**MAJOR PROJECT ASSESSMENT:  
Section 75W Modification  
6 -16 Atchison Street, St Leonards  
(09\_0187 MOD 2)**

Director-General's  
Environmental Assessment Report  
Section 75W of the  
*Environmental Planning and Assessment Act 1979*

February 2014

Figure 3: Approved loading area - Basement level 1

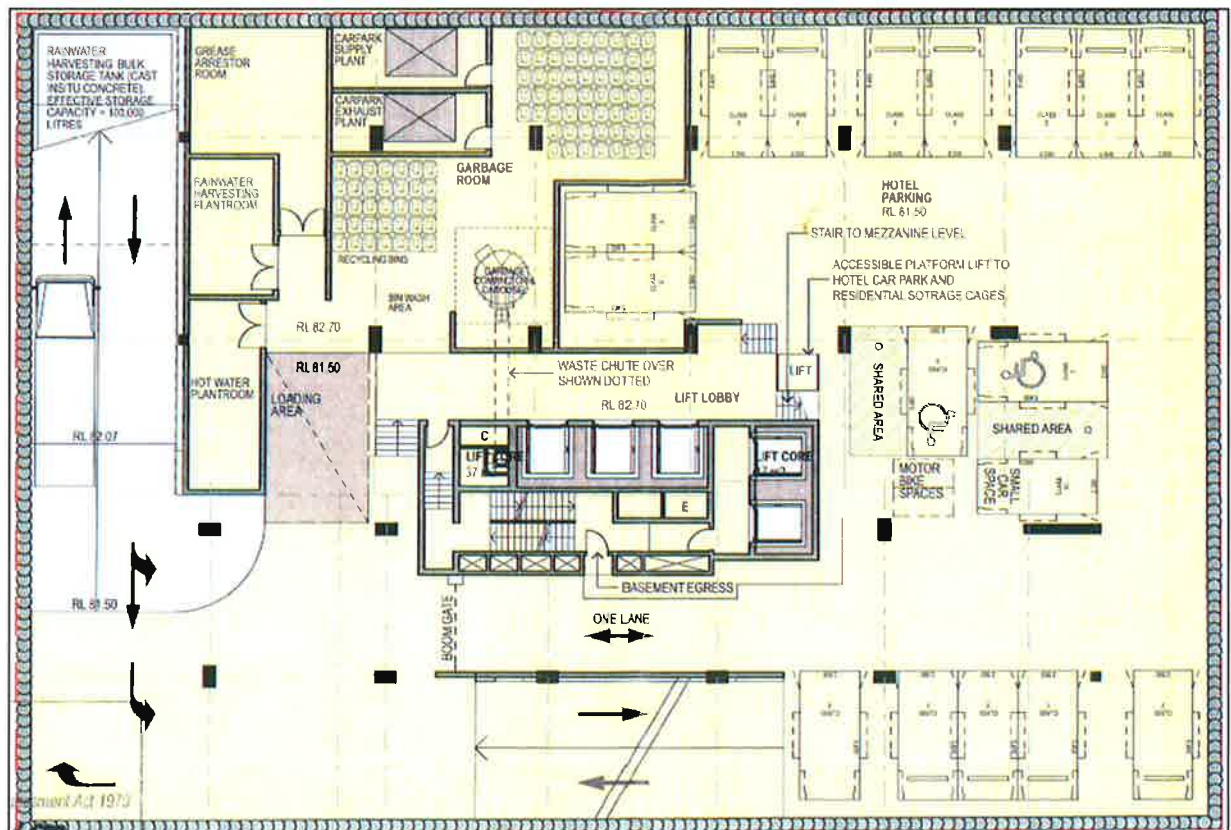
The application seeks to retain the basement servicing and access as per the Project Approval (**Figure 3**). The vehicular entry point, circulation areas and clearance of the basement levels are proposed to be modified (**Figure 4**). Consequently, the building services have been adjusted to accommodate the revised garbage storage and collection arrangement. This includes adjusting the public domain area RL to allow for the required height clearance.

Figure 4: Proposed Basement level 1 as per the traffic expert's recommendations

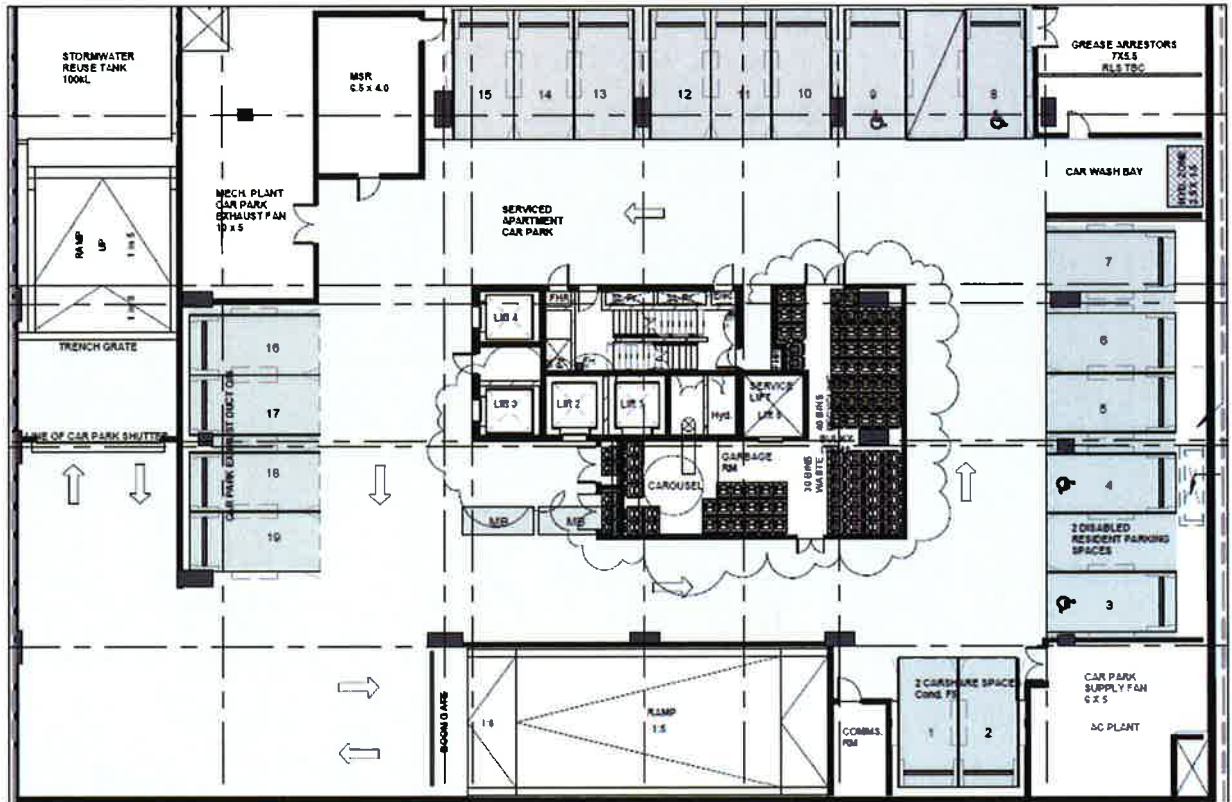
The agency engaged ARUP, an independent traffic expert, to review the proposed basement layout and provide an assessment of the proponent's justification for an at-grade loading dock on Atchison Lane (as proposed in the application as lodged). ARUP concluded that the basement ramp could be redesigned (to accommodate a Council garbage vehicle to a 3.6 m height clearance). This would significantly reduce the length of the ramp and associated loss of ground level public domain compared with the application as lodged, and is similar to the approved scheme.

The response to submissions incorporates the recommendations of the agency's traffic expert who confirmed the design complies with the Australian Standards, and is satisfactory in terms of internal manoeuvrability and ramp design subject to a minor amendment to ensure adequate vertical headroom clearance (at points 1 and 2 in **Figure 5**). This is reflected in the recommended modification instrument. The agency supports the application and recommends the Project Approval be modified in accordance with the traffic expert's recommendations.

- (b) The basement ramp design, grades and overhead clearance between Atchison Lane and the Basement 1 loading area shall be generally in accordance with ARUP's letters to the Department of Planning and Infrastructure dated 18 December 2013, 20 December 2013 and 5 February 2014. In this regard, the access ramp is to be modified to increase the headroom clearance at the two locations specified in Arup's letter dated 5 February 2014;**
